**HISTORIC PRESERVATION COMMISSION
MEETING AGENDA**

BUTTE-SILVER BOW HISTORIC PRESERVATION COMMISSION CERTIFICATE OF APPROPRIATENESS (COA) APPLICATION

Address: 823 S. Main St., Butte
Addition/Block/Lot: Ophir Addition/Block 8/Lots 22-23
Other Legal Description: Section 25, Township 3 North, Range 8 West

**BUTTE MONTANA
 4-PLEX**
 MAIN STREET BUTTE, MONTANA

Front (south) façade.

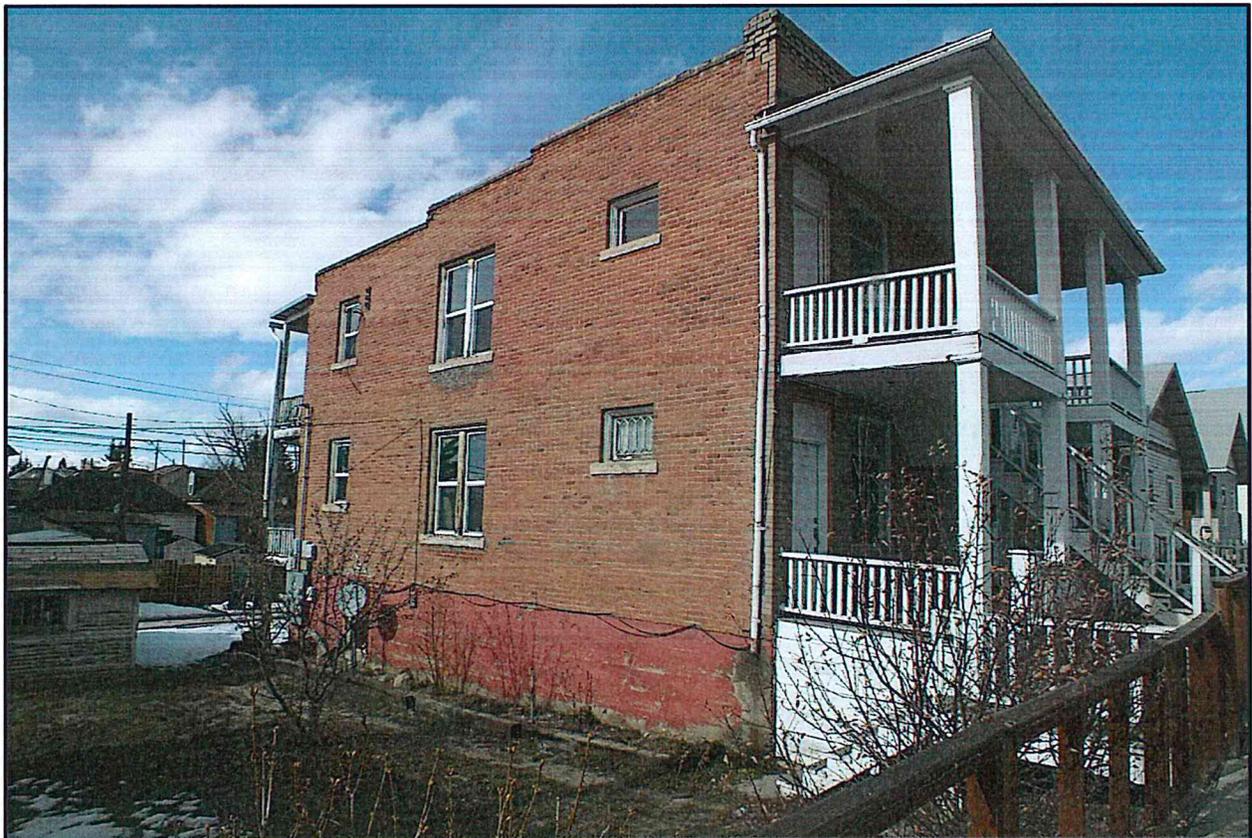
- Replace the four, wood-sash cottage windows (one at each apartment) on the front (east) façade. These are all original units distinguished by a decorative upper sash featuring muntins in a diamond pattern. Replacements would be metal-clad, wood sash cottage

- Replace all exterior (front and back) doors. One historic Craftsman-style wood door remains, but most if not all of the other doors are modern replacements made of metal. The proponents proposes all new doors made of paneled wood. Transom windows at each entry will also be restored;

Front apartment with metal replacement door, blocked transom, and original cottage window

Front apartment with historic Craftsman-style door, intact transom, and original cottage window

STAFF RECOMMENDATION: The Historic Preservation Officer (HPO) finds that the exterior rehabilitation work/modifications proposed by this RRA project are historically compatible. Project approval is recommended.

**Route of chases from southwest corner of engine house remains:
east-west chase to office/dry at left and north south chase to headframe at right**

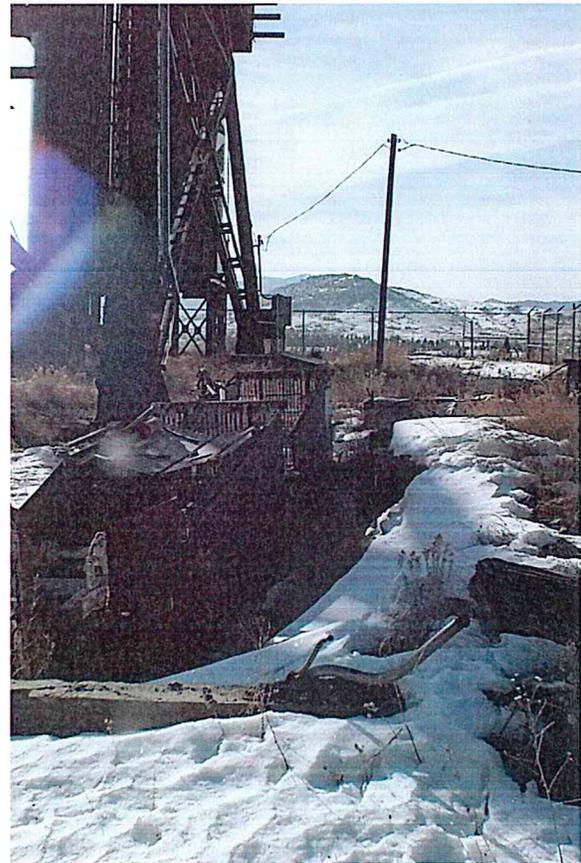
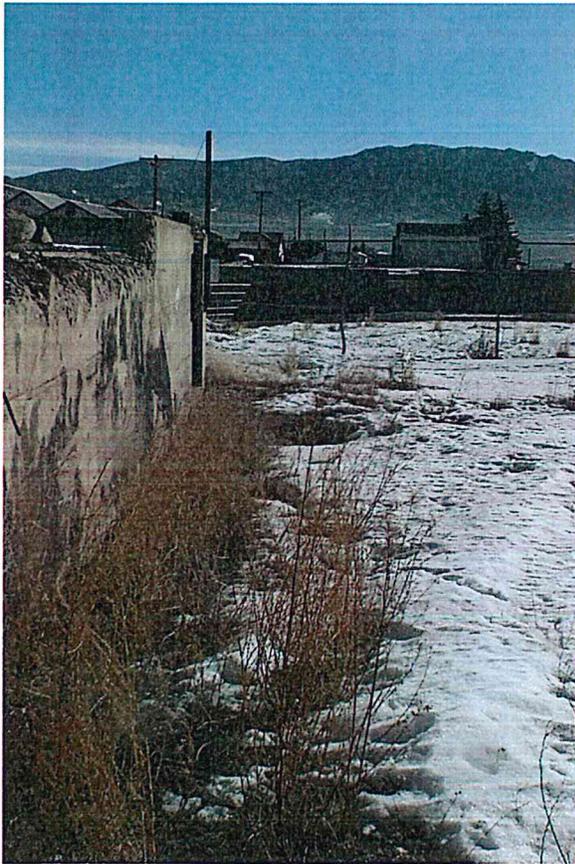
The City-County proposes to collapse and fill the utility chases due to the hazardous conditions that they present. Both chases lie only a few inches below the ground, and each contains asbestos. Recently, workers that had come to the Travona to inspect a modern pumping station near the headframe, inadvertently drove over the north-south chase and the wheels of their vehicle collapsed into the roof.

The City-County proposes to use a front-end loader to collapse and compact the chases. Work will essentially involve lifting up and dislodging a section of chase, dropping and tapping the material back in the opening, and then adding fill. This will allow the asbestos to be contained in place.

STAFF RECOMMENDATION: The Historic Preservation Officer (HPO) recommends project approval to remediate a hazardous condition. To mitigate the loss of the utility chases, the HPO proposes that the City-County leaves at least the first 6 feet of each chase from the engine house in place, and installs a wire gate at the entrance so that the remaining sections can be viewed but not accessed. During the collapse and fill project, exposed sections of chases should be photo-documented. Additionally, the Travona Mine, including all structures and archaeological features, should be inventoried at the intensive level and the findings documented on a Montana Historic Property form. The HPO will have responsibility for the photography work during collapse and fill, and conducting the inventory and evaluation project.
